Subject: Catawba Nuclear Station
Docket Numbers 50-413 and -414
Proposed Change to MSSV Technical Specification
Setpoint Tolerances; Supplemental Information

By letter dated November 15, 1995, Duke Power Company submitted proposed changes to main steam safety valve setpoint tolerance values. The NRC staff responded with a request for additional information (RAI) dated March 19, 1996. Attached are responses to the RAI.

Attachment 2
Revised Technical Specification Table 3.7-1

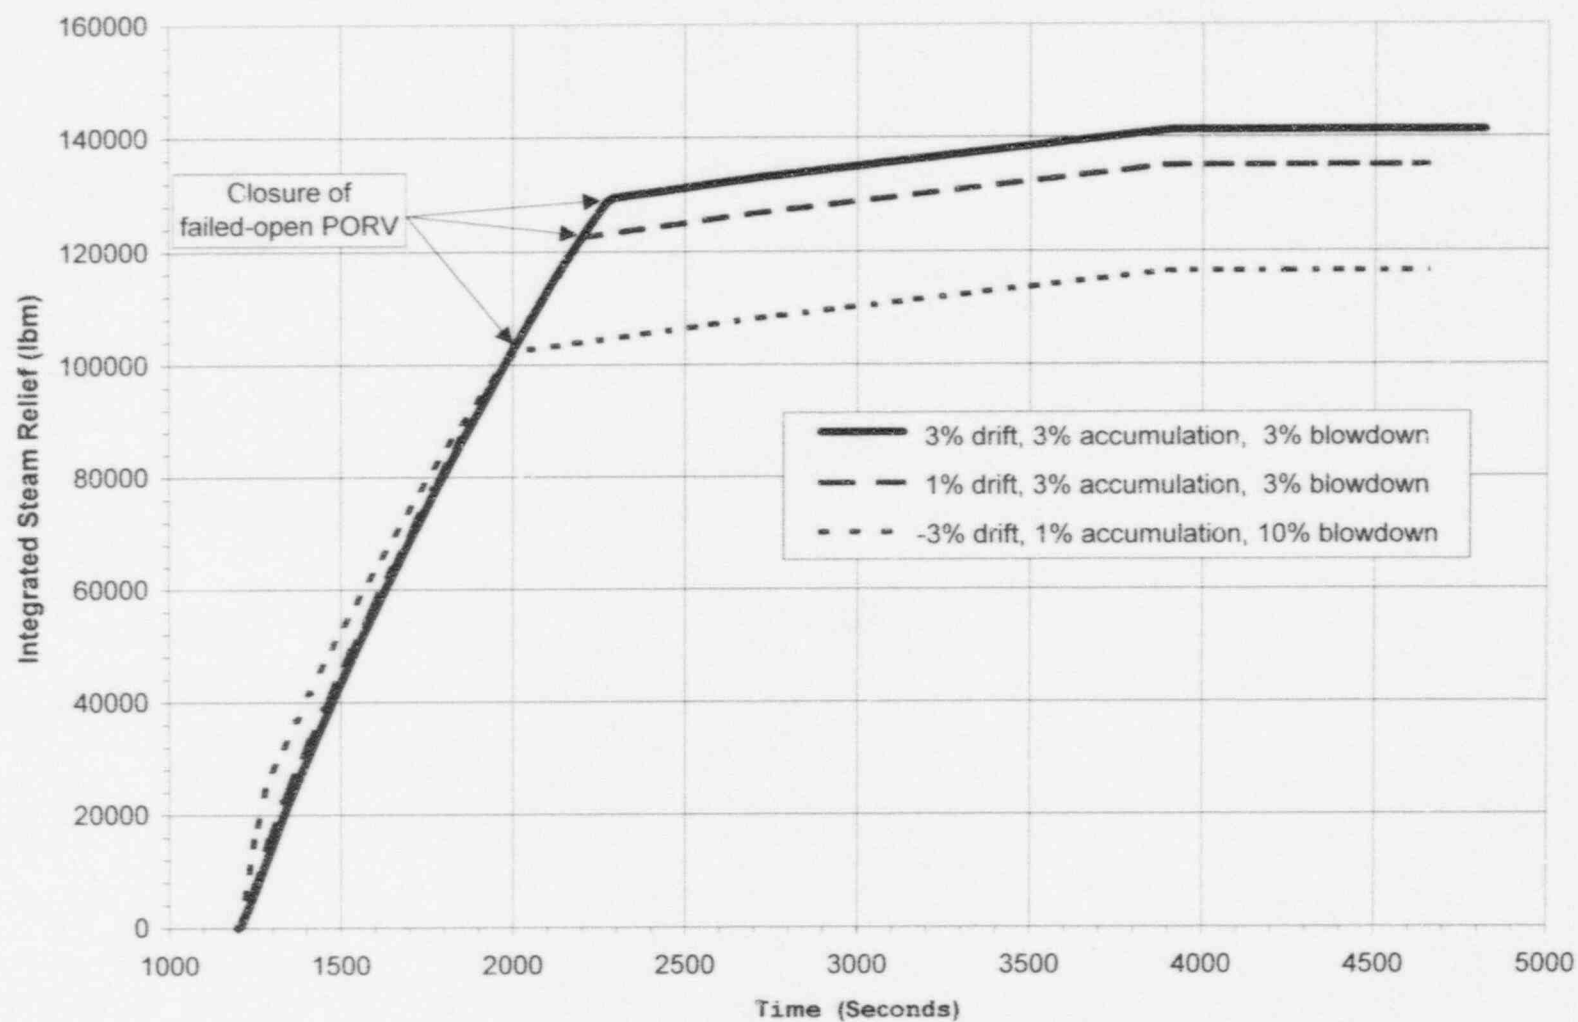
Provide clarification for the changes made to TS Table 3.7-1.

The change to Table 3.7-1 as submitted included a typographical error. The intent of the change was to remove both the footnote and the final line of the table which allowed operation in Mode 3 with 4 or 5 inoperable MSSVs. A replacement page for that Technical Specification change is included as Attachment 2.
